December 08, 2017

SUBJECT: NuScale Power, LLC Submittal of Changes to Part 2 Tier 2 Final Safety Analysis Report, Chapters 1, 4 and 15 and Part 4, Technical Specifications

Enclosure: Changes to NuScale Part 2 Tier 2 Final Safety Analysis Report Chapters 1, 4 and 15
and Part 4, Technical Specifications

Figure 15.4-32: ~~CHFR (15.4.8 Rod Ejection Accident)~~Not Used

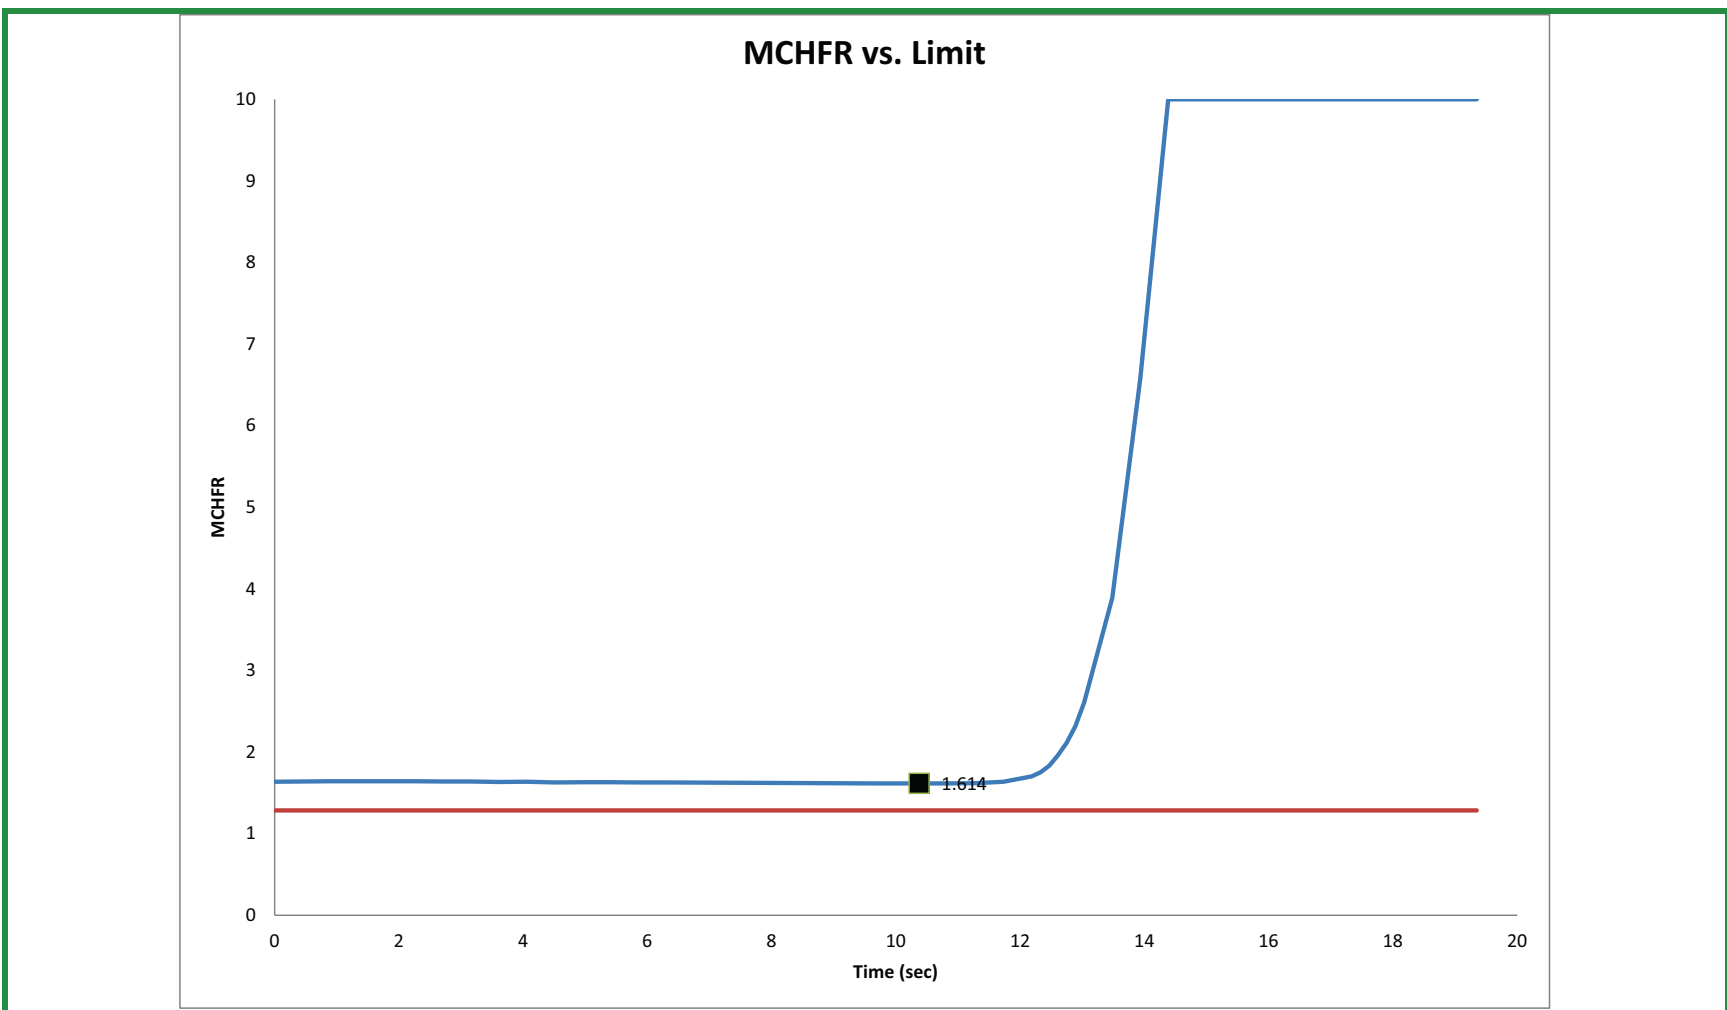
The subchannel analysis evaluates a spectrum of REA conditions that are provided by the S3K and NRELAP5 analyses. The REA case that results in the limiting MCHFR is an REA that occurs at an initial power of 70% at EOC. The limiting MCHFR ~~is 1.47,~~ which is above the design limit as demonstrated in ~~Figure 15.4-32~~ Figure 15.4-37.
